TO: CANNON FALLS CITY COUNCIL
FROM: Neil Jensen, City Administrator
SUBJECT: Rezone and Preliminary Plat for Greg Jablonske, Towering Bluffs, First Addition
DATE: May 4, 2021

Rezone and Preliminary Plat for Greg Jablonske, Towering Bluffs, First Addition. A public hearing was held by the Planning Commission April 12th to consider a request by Greg Jablonske for a rezone and preliminary plat for Towering Bluffs proposing a 22-lot subdivision. This plat is currently zoned as an *R-2 Single Family Residential District*. Mr. Jablonske is requesting the zoning be changed to a PUD. This will allow for smaller and affordable lots which the city has been striving to obtain to spur growth in the community.

RE: Cannon Falls, MN
Towering Bluffs Subdivision
Review of Preliminary Plat and Plans

TOWERING BLUFFS
 DARIUS PALM, PROFESSIONAL SURVEYOR
 PRELIMINARY PLAT
 GREG J. HOMES
 3415 VERNILSON ST., HASTINGS, MN 55033

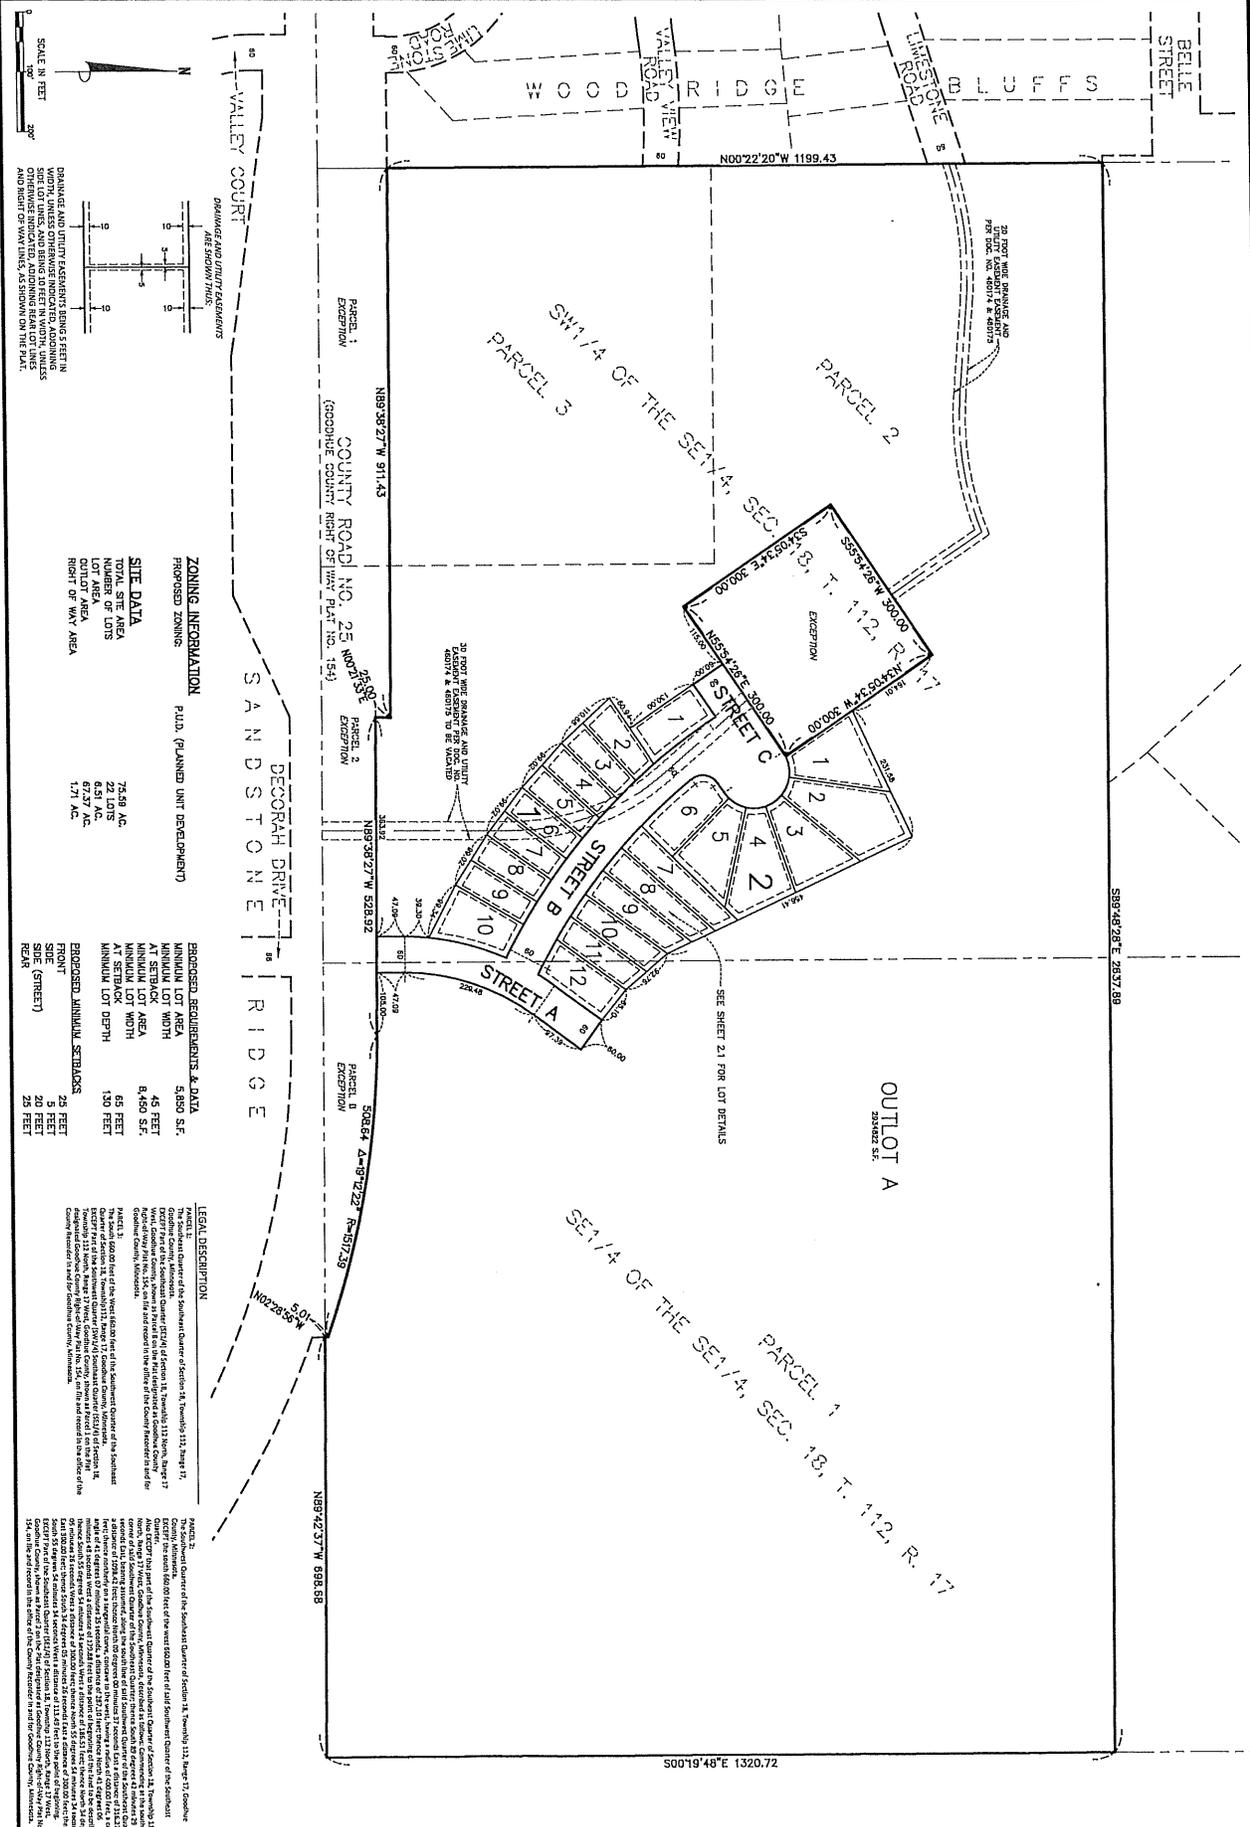
2. A general development plan was previously submitted in February 2003 and was included in the approved Environmental Assessment Worksheet (EAW). The City should discuss if a revised sketch plan is needed since this plat deviates from the original plan included in the EAW.

4. During the final plan review, all engineered fill areas should be shown on the final plans.
5. A pre-application meeting and neighborhood meeting are recommended for this subdivision per section 151.077 (A) and (B) of the ordinance.

8. A 12-inch watermain is shown between Lots 7 and 8, Block 1 for a watermain connection to the existing watermain. A 10-foot easement is shown on the plat. We recommend a minimum 20-foot-wide utility easement.
9. Temporary hydrants should be considered at the dead end watermain stubs.
10. Sidewalks should be shown on both sides of the proposed typical section. Sidewalk is currently shown in the typical section on one side but not on the plan.
11. Grading between houses should show positive drainage away from houses. The proposed grading plan doesn't provide enough detail.
12. A geotechnical and hydraulic report should be submitted for the subdivision with the final plat and plans. Please note the area to the south had problems with expansive soils.

We would recommend approval of the proposed plat and plans conditional upon the above items being addressed.
